# UNITED STATES PATENT AND TRADEMARK OFFICE

APPLICATION NO.	FILING DATE	FIRST NAMED INVENTOR	ATTORNEY DOCKET NO.	CONFIRMATION NO.
10/522,241	10/05/2005	Satoshi Sugahara	HIRA.0178	1606
38327	7590	05/31/2007		
REED SMITH LLP 3110 FAIRVIEW PARK DRIVE, SUITE 1400 FALLS CHURCH, VA 22042			EXAMINER VALENTINE, JAMI M	
			ART UNIT 2815	PAPER NUMBER
			MAIL DATE 05/31/2007	DELIVERY MODE PAPER

## Office Action Summary

## **DETAILED ACTION**

*Prior Art: Noguchi Figure 34C teaching a spin-tunneling device.*

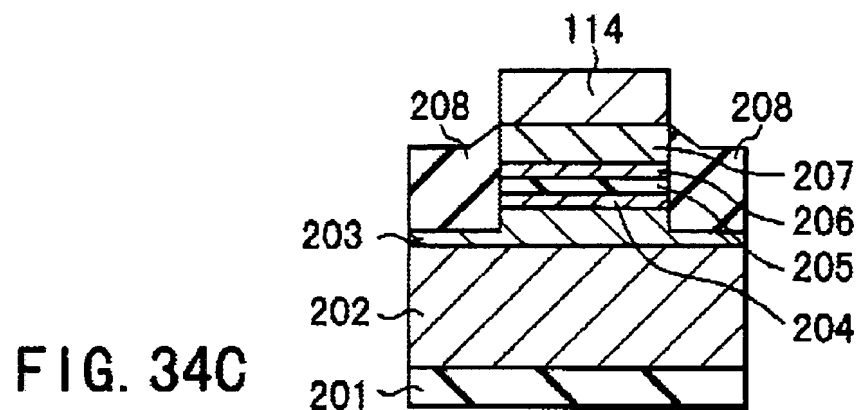
**Claims 71-82** are rejected under 35 U.S.C. 102(b) as being anticipated by Noguchi et al. (US Patent Application Publication No 2003/0013843) hereinafter referred to as Noguchi.

- a spin injector ((203), (204), and (205)) for injecting spin-polarized hot carriers by a spin-filter effect;
- a spin analyzer ((205), (206), and (207)) for selecting the thus injected spin-polarized hot carriers by the spin-filter effect.

18. Additionally, claim 1 recites the performance properties of the spin injector and the spin analyzer. This functional limitation does not distinguish the claimed device over the prior art, since it appears that this limitation can be performed by the prior art structure of Noguchi. While features of an apparatus may be recited either structurally or functionally, claims directed to an apparatus must be distinguished from the prior art in terms of structure rather than function. In re Schreiber, 128 F.3d 1473, 1477-78, 44 USPQ2d 1429, 1431-32 (Fed. Cir. 1997) See MPEP 2114.

19. Per **Claim 72** Noguchi discloses the device of claim 71 including where the spin injector ((203), (204), and (205)) comprises

- a first ferromagnetic barrier layer (204) through which the carriers can be transported by tunneling upon application of a voltage across said first ferromagnetic barrier layer;
- a first nonmagnetic electrode layer (203) joined to one end surface of said first ferromagnetic barrier layer; and
- a second nonmagnetic electrode layer (205) joined to the other end surface of said first ferromagnetic barrier layer.

20. Per **Claim 73** Noguchi discloses the device of claim 71 including where spin analyzer ((205), (206), and (207)) comprises

- a second ferromagnetic barrier layer; (206)
- a second nonmagnetic electrode layer (205) joined to one end surface of said second ferromagnetic barrier layer; and
- a third nonmagnetic electrode layer (207) joined to the other end surface of said second ferromagnetic barrier layer,
- wherein said second nonmagnetic electrode layer (205) is common to said spin injector and said spin analyzer.

25. Per **Claim 82** Noguchi discloses the device of claim 81 including where said second nonmagnetic electrode layer (205) of said transistor is connected to a wordline (202) , said third nonmagnetic electrode layer (207) of said transistor is connected to a bitline (114), said bitline is connected to a power supply via a load, and said first nonmagnetic electrode layer of said transistor is connected to ground (column 25 lines 41-59).
